Product Change Notice (PCN)

PCN Number: **PCN-0451180R-01**

Product(s) Affected: **PJ-047B**

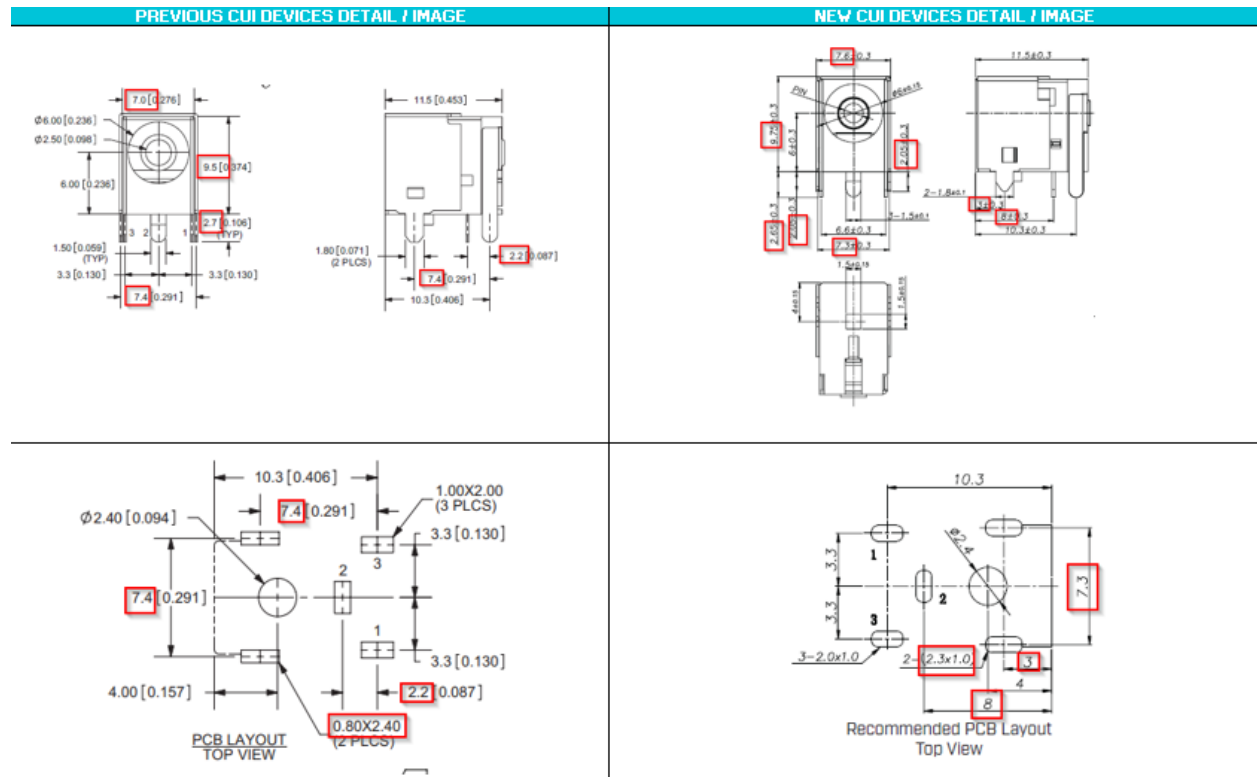
Description of Change: **Minor Housing and footprint differences. Material Change on the housing and terminals. See image Below**

PREVIOUS CUI DEVICES DETAIL / IMAGE			NEW CUI DEVICES DETAIL / IMAGE		
	MATERIAL	PLATING		MATERIAL	PLATING/COLOR
center pin	copper	nickel	DESCRIPTION	brass	nickel
terminal 1	brass	tin	terminal 1	brass t=0.30	silver
terminal 2	copper alloy	tin	terminal 2	SUS301 t=0.30	silver
terminal 3	brass	tin	terminal 3	brass t=0.30	silver
			shield	brass t=0.25	nickel

PREVIOUS CUI DEVICES DETAIL / IMAGE						NEW CUI DEVICES DETAIL / IMAGE					
SPECIFICATIONS						SPECIFICATIONS					
parameter	conditions/description	min	typ	max	units	parameter	conditions/description	min	typ	max	units
rated input voltage			24		Vdc	rated input voltage			24		Vdc
rated input current				2.5	A	rated input current				2.5	A
contact resistance	between terminal and mating plug between terminal in a closed circuit			50	mΩ	contact resistance				30	mΩ
insulation resistance	at 500 Vdc			100	MΩ	insulation resistance	at 250 Vdc			100	MΩ
voltage withstand	at 50-60Hz for 1 minute			500	Vac	voltage withstand	for 1 minute			500	Vac
insertion/withdrawal force		0.3		3	kg	insertion/withdrawal force		0.3		3	kg
terminal strength	any direction for 10 seconds			500	g	operating temperature		-25		85	°C
operating temperature		-25		85	°C	life				5,000	cycles
life				5,000	cycles	flammability rating	UL94V-0				
flammability rating	UL94V-0					RoHS	yes

SOLDERABILITY					
parameter	conditions/description	min	typ	max	units
wave soldering	dipped in solder pot for 5-10.5 seconds	255	260	265	°C

SOLDERABILITY					
parameter	conditions/description	min	typ	max	units
wave soldering	dipped in solder pot for 4-6 seconds		250		°C
